## MEMORANDUM

**To:** The Design Advisory Board  
**From:** Mary O'Neil, AICP, Principal Planner  
**RE:** ZP19-0485CA; 131 Lakeview Terrace  
**Date:** January 8, 2019

**Request:** Modification to plans approved under ZP18-0757CA;

**2 ELEVATION - WEST**  
1/4" = 1'-0"

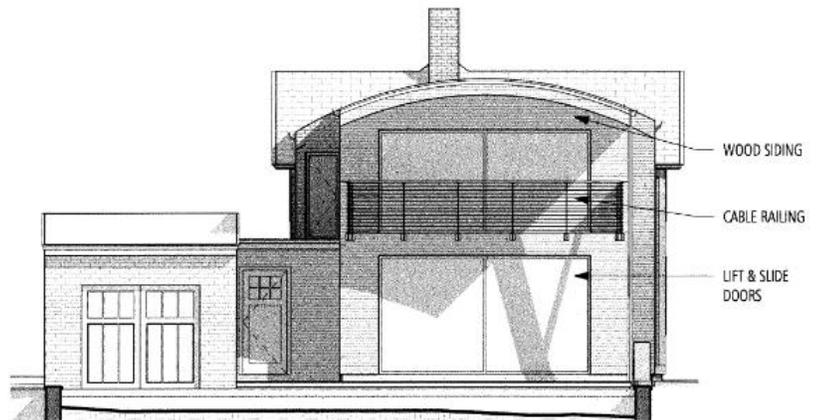
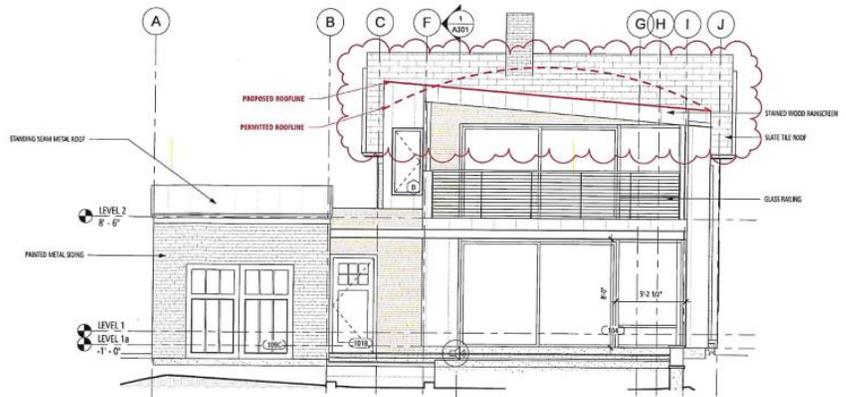
Proposed revision to addition roofline

The addition, although large, is located behind the principle structure and will remain largely out of view from the public street. The height does not exceed that of the existing historic home **if the changes to the roof pitch of the historic home are approved**. The change from a barrel roof to a shed roof is of no consequence relative to the perceived massing of the building.

As the addition remains in the rear of the existing building, it will not be easily discernable from the public realm. The proposed change to a shed roof on the rear addition will be both unobservable and without conflict. The change to the roof on the primary structure will be consistent with the style of the existing roof (transecting gable) and upon completion should not present a marked departure from the existing appearance.

The altered roof on the rear addition will not be evident from the street edge. The raised transverse gable on the historic house will not likely be discernable, but again introduce a change to the character of the historic house.

The altered rear (addition) roof is consistent with these standards and complimentary to the overall design.
